## Freelander Carpet mat fixings SSM (L359) 1a.JPG

Reference SSM62297

Title L359 Freelander & Range Rover Sport front carpet mat fit

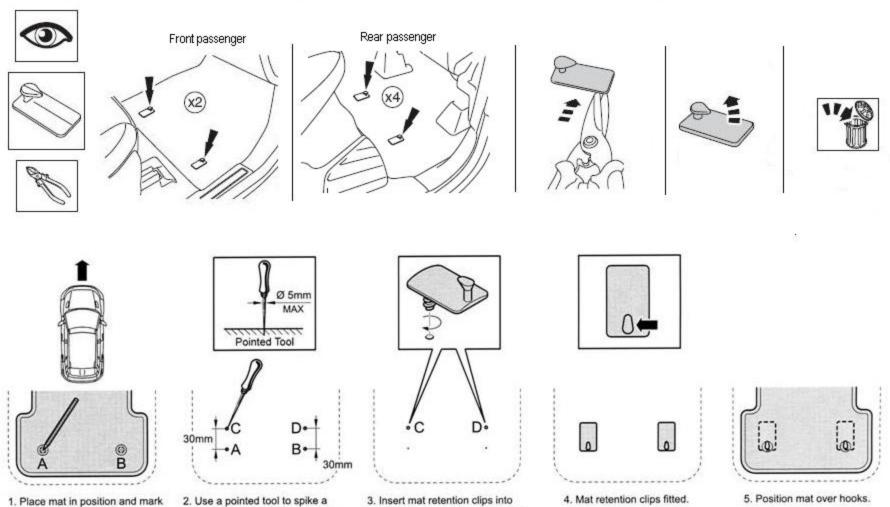
Front carpet clip location may be incorrect

Content Poor clip position

If it is seen that the front carpet mat does not fit correctly

follow the attached instruction

points C and D and turn clockwise

until they turn freely.

small hole in the carpet at points C and D, 30mm forward of marks

A and B.

centre of hole positions.

4. Mat retention clips fitted. 5. Position mat over hooks.
